Reply to Office Action of July 21, 2005

# Amendments to the Drawings:

Serial No. 10/698,382 Amdt. dated October 21, 2005 Reply to Office Action of July 21, 2005

Chang-bong CHOI Serial No. 10/698,382

FIG. 2a PRIOR ART

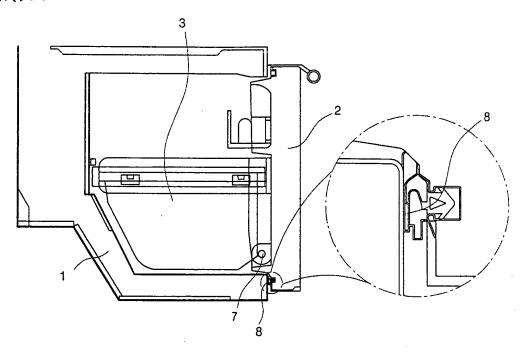
The Office Action objects to the drawings. Figures 1 and 2a-2c have been amended to include the legend "Prior Art," as suggested by the Examiner. Accordingly, it is respectfully submitted that the objection should be withdrawn.

The attached drawings include changes to Figures 1 and 2a-2c. These sheets, which include Figures 1, 2a-2c, and 3a, replace the original sheets including Figures 1, 2a-2c, 3a. Figures 1 and 2a-2c have been amended to include the legend "Prior Art," as requested by the Examiner. No new matter is added.
